YOUNG NAK PRESBYTERIAN CHURCH / YOUNG NAK RETREAT CTR. / LNDG #2239-01

**COUNTY OF LOS ANGELES FIRE DEPARTMENT PREVENTION SERVICES BUREAU FUEL MODIFICATION PLAN NOT APPROVED RESUBMIT**

**PRELIMINARY LANDSCAPE & FUEL MODIFICATION PLAN**

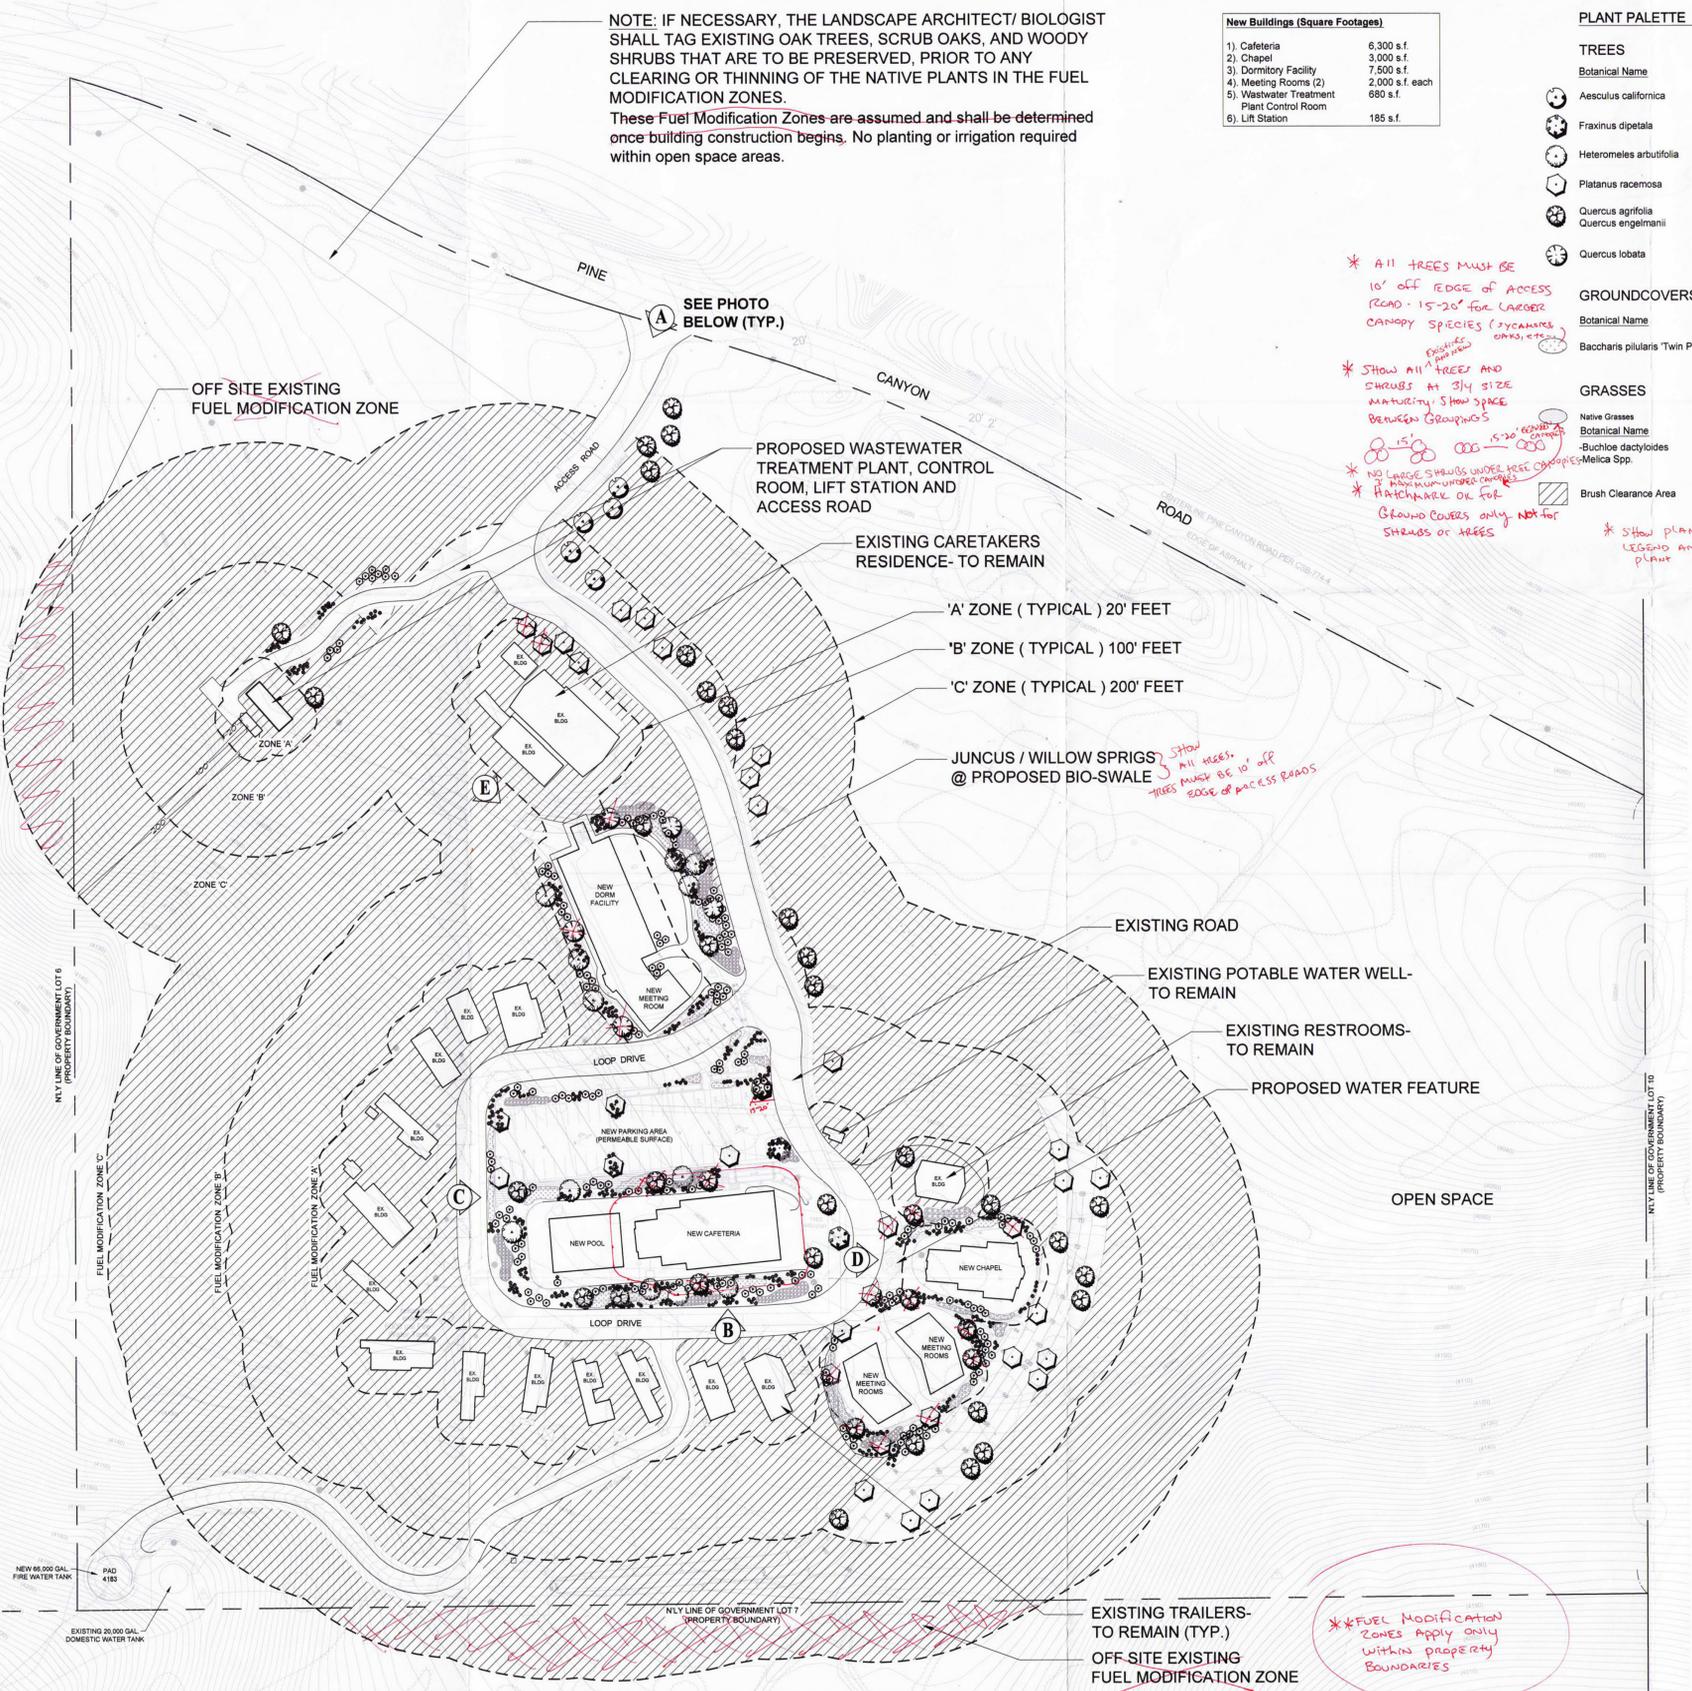
*\* All trees must be 10' off edge of access road - 15-20' for larger canopy species (sycamores, oaks, etc.)*

*\* Show all trees and shrubs at 3/4 size maturity. Show some between groupings.*

*\* NO LARGE SHRUBS UNDER REST CHAMISE. HATCHMARK OR FOR BRUSH CLEARANCE ONLY NOT FOR SHRUBS OR TREES*

*\* Show planting numbers on legend and symbols for each plant*

*JUNCUS / WILLOW SPRIGS @ PROPOSED BIO-SWALE*

*SHOW ALL TREES. TREES MUST BE 10' OFF EDGE OF ACCESS ROADS*

*\*\*FUEL MODIFICATION ZONES APPLY ONLY WITHIN PROPERTY BOUNDARIES*
